**Re: VARIANCE REQUEST
HERMAN RESIDENCE
31 SANDS AVENUE
ANNAPOLIS, MD 21403
TM 57, GRID 10 PARCEL 29**

**Re: VARIANCE POINT-BY-POINT RESPONSE TO PRE-FILE COMMENTS
2025-0028-P
HERMAN RESIDENCE
31 SANDS AVENUE
ANNAPOLIS, MD 21403
TM 57, GRID 10 PARCEL 29**

ADMINISTRATIVE SITE PLAN VARIANCE ADMINISTRATIVE PLAN FOR 31 SANDS AVE 31 SANDS AVENUE, ANN ARBOR, MI 48103 TAX MAP 57, GRID 02, PARCEL 20, LOT 3 TAX ID: 02-047-0444650 SECOND DISTRICT - ANNE ARUNDEL COUNTY - ZONED R2	Sheet No. 3 OF 3
---	-------------------------

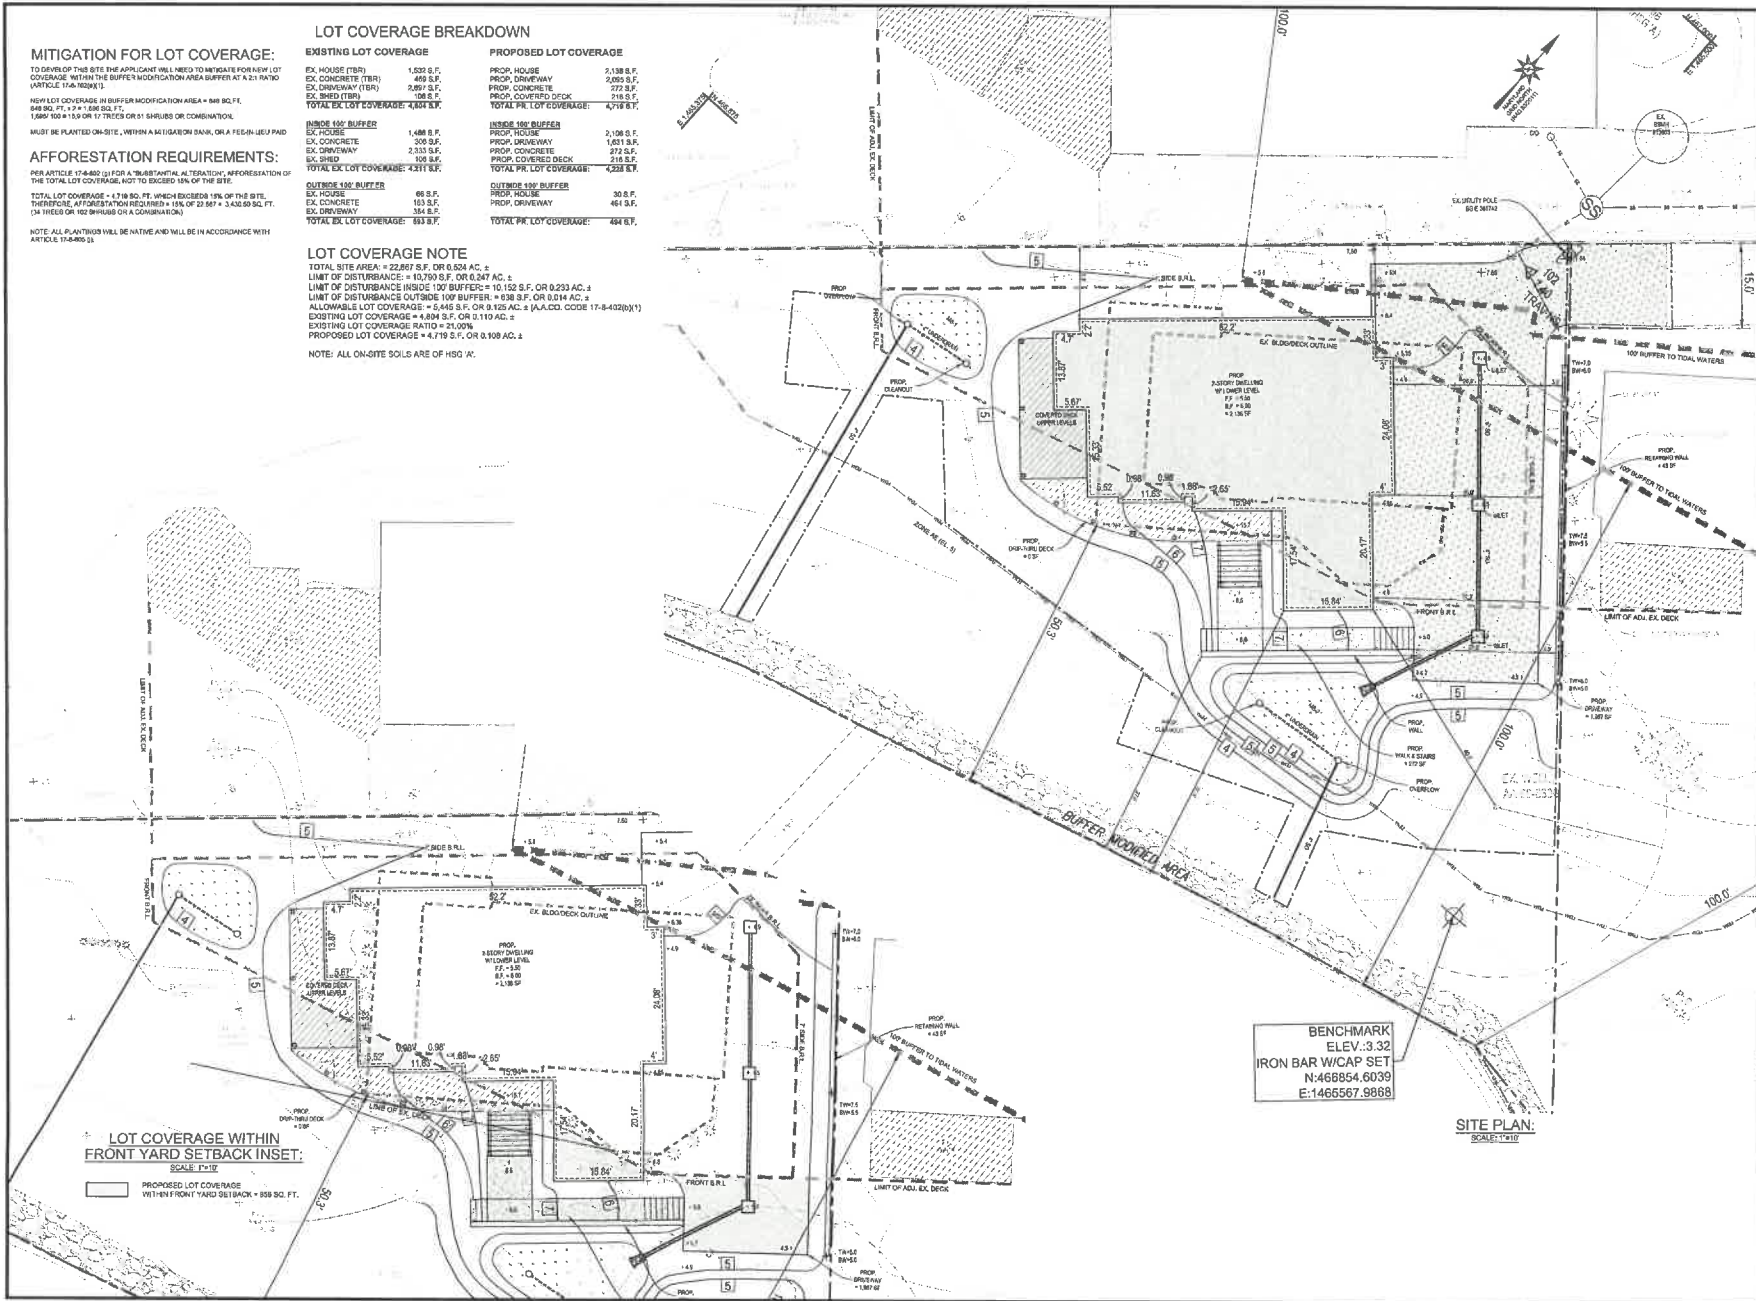
Comment 1: The setback lines are not accurately depicted on the Administrative Site Plan and must be revised. The northeastern lot line, abutting 29 Sands Avenue, is considered the rear lot line rather than the apex of the lot lines. In addition, the front setback line should be marked at 30 feet from the mean high-water line, rather than the limits of the adjacent decks/principal structures.

Comment 2: The lines designating the limits of the adjacent decks/principal structures are not accurately depicted on the Administrative Site Plan and must be revised. As confirmed with the Critical Area Team, the lines should follow the plane of the outer limits of the decks and converge, rather than adding a third angled line between the two.

Comment 3: Based on the above revision, it appears that a variance to 18-2-402 may be eliminated by shifting the proposed dwelling closer to the northwest side lot line, or by reducing the dimensions of the proposed dwelling. If not, the Letter of Explanation will need to be revised to provide justification as to why it is not possible to either shift the dwelling or adjust the dimensions.

Comment 4: The new lot coverage nearer to the shoreline than the closest facade was not accurately calculated. Revise the Letter and Site Plan to correctly identify the area of new lot coverage forward of the existing dwelling's facade as shown below. Adequate justification as to why it's not possible to rebuild the dwelling, walkways and driveway without expanding the lot coverage closer to the shoreline is required.

Comment 3. Show and label the existing utility easement on the plan.

Response 1: *The setback lines have been adjusted as requested.*

Response 2: *The limits of the adjacent decks/principal structures has been revised as requested.*

Response 3: *As suggested the applicant has reduced the house footprint and shifted the building northwest side lot line to avoid the need for a variance to Article 18-2-402(1).*

Response 4: *The new lot coverage has been revised based on the comment. Refer to the letter of explanation for adequate justification.*

Response 3. A 10' wide public utility easement has been noted on the plans

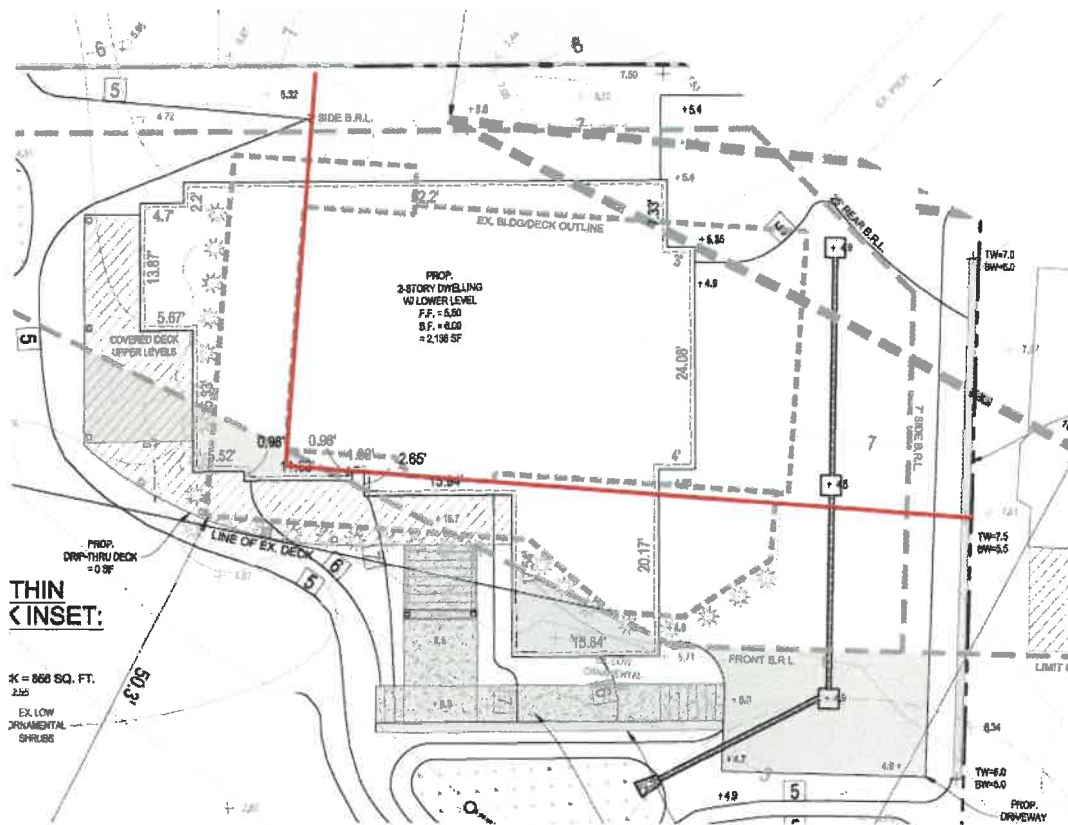
4. The new lot coverage nearer to the shoreline than the closest facade was not accurately calculated. Revise the Letter and Site Plan to correctly identify the area of new lot coverage forward of the existing dwelling's facade as shown below. Adequate justification as to why it's not possible to rebuild the dwelling, walkways and driveway without expanding the lot coverage closer to the shoreline is required.

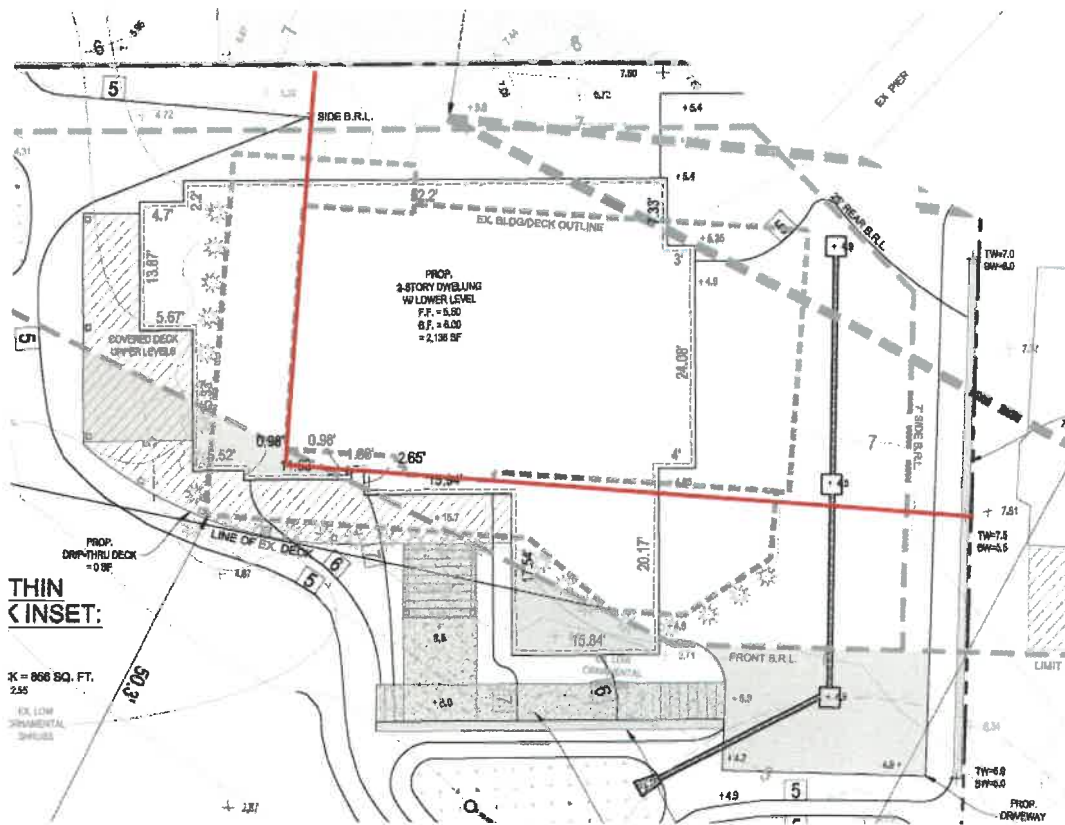
4. The new lot coverage nearer to the shoreline than the closest facade was not accurately calculated. Revise the Letter and Site Plan to correctly identify the area of new lot coverage forward of the existing dwelling's facade as shown below. Adequate justification as to why it's not possible to rebuild the dwelling, walkways and driveway without expanding the lot coverage closer to the shoreline is required.
